Access Compliance Report

Public Rights-of-Way

Intersection ID: 48770	Main Street: TURNING_WHEEL_DR	Cross Street: KNOTHOLE_LN	Location: NE
ADA ID: 4780BCE347B2	Ramp Type: Perp	Initial Pass/Fail: Fail	Overall Compliance: No
Codes/Mitigation Info/Possible Solution		Field Measurements/Component Compliance	
Severity Score: 13.75

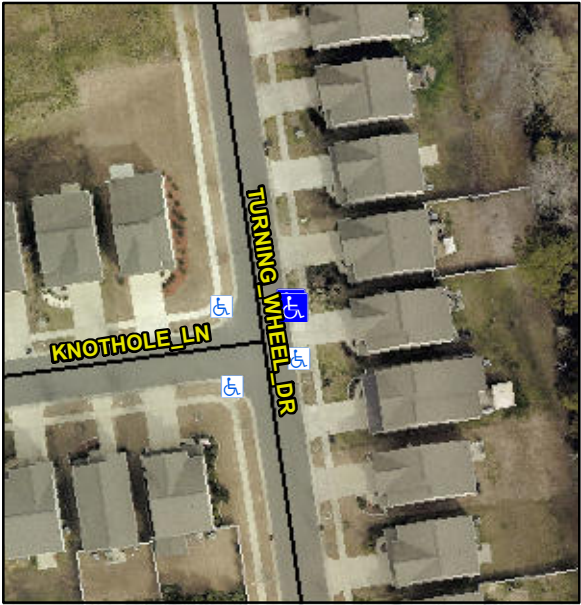
Possible Solutions:	Compliance	Description	Data	Compliance	Description	Data
	Remove & Replace Entire Ramp.	N/A	Ramp Length (in)	72.0	No	Ramp Slope (%)	8.8
		Yes	Ramp Width (in)	48.0	No	Ramp XSlope (%)	2.1
		N/A	Flare Type LT	N/A	N/A	Flare Type RT	N/A
		N/A	Flare Slope LT (%)	N/A	N/A	Flare Slope RT (%)	N/A
		N/A	Flare Traversable LT?	N/A	N/A	Flare Traversable RT?	N/A
		N/A	Landing Length (in)	N/A	N/A	DWS Provided?	N/A
		N/A	Landing Width (in)	N/A	N/A	DWS Contrast?	N/A
		N/A	Landing Slope (%)	N/A	N/A	DWS Length (in)	N/A
		N/A	Landing X Slope (%)	N/A	N/A	DWS Full Width?	N/A
		N/A	Landing Curb? (Y/N)	N/A	N/A	DWS Offset (in)	N/A
		N/A	Shared Landing?	N/A			
		N/A	Gutter Ponding?	N/A	N/A	Gutter Slope (%)	N/A
		N/A	Gutter Lip Ht (in)	N/A	N/A	Gutter X Slope (%)	N/A
		N/A	Painted X Walk1?	No	N/A	Painted X Walk2?	N/A
			X Walk 1 Direction	To W		X Walk 2 Direction	N/A
		N/A	X Walk 1 Width (in)	N/A	N/A	X Walk 2 Width (in)	N/A

X Walk 1 Slope (%)	3.0		X Walk 2 Slope (%)	N/A
			X Walk 1 X Slope (%)	1.9		X Walk 2 X Slope (%)	N/A
		N/A	Ramp inside XWalk1?	N/A	N/A	Ramp inside XWalk2?	N/A
Surveyor Notes: N/A PROW/ADA: Not Found, R304.2.2, R304.5.3			Road Slope (%)	N/A	N/A	Clear Space?	N/A
			Road X Slope (%)	N/A	N/A	Clear Space to XWalk (in)	N/A
		N/A	Any Obstructions?	N/A	N/A	Storm Grate/Utility Hazard?	N/A
			Obstruction Type			Storm Grate/Utility Type	
					N/A		N/A
					Yes	Surface Condition? (G/P)	Good
